# **Coshocton Port Authority Coshocton Collaborative**

### Addendum No. 3 – 19.137

December 11th 2023

FIRST FLOOR REFLECTED **CEILING PLAN**

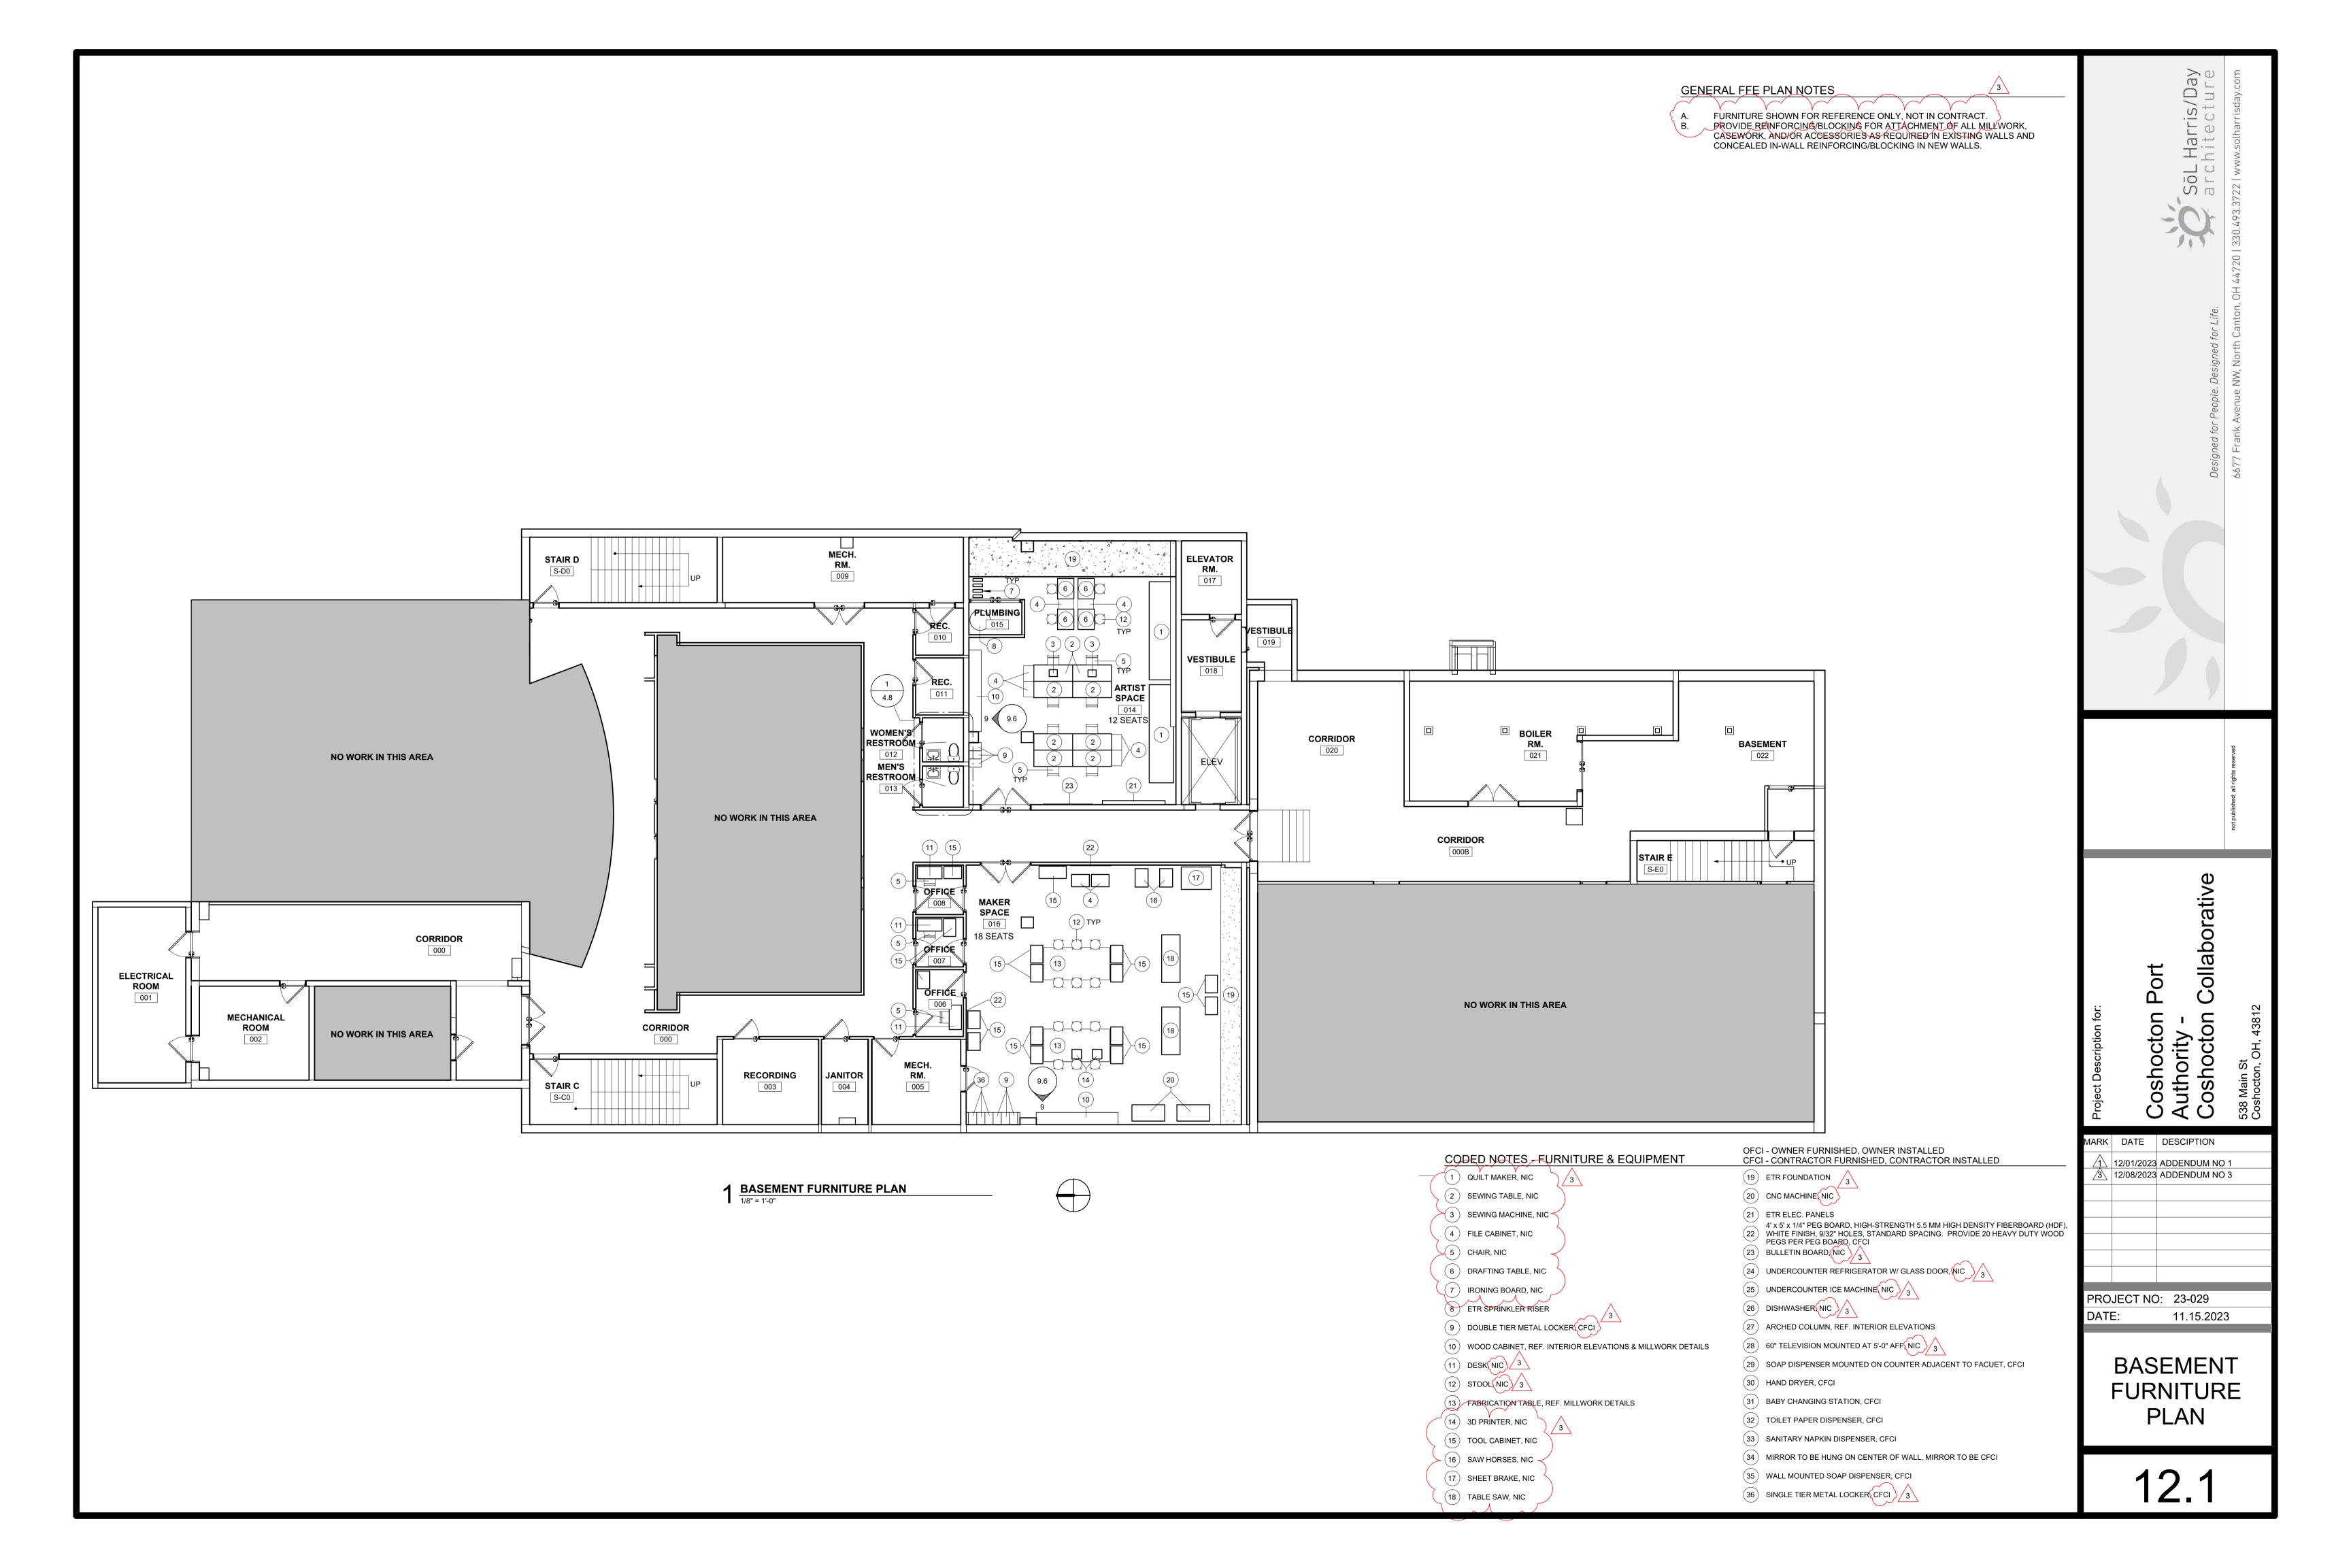
- b. Add SAU-2 Ceiling Baffle Typical Elevation 5.
- 4. 10.2 FIRST FLOOR REFLECTED CEILING PLAN
  - a. Dimension SAU-1
- 5. 12.1 BASEMENT FURNITURE PLAN
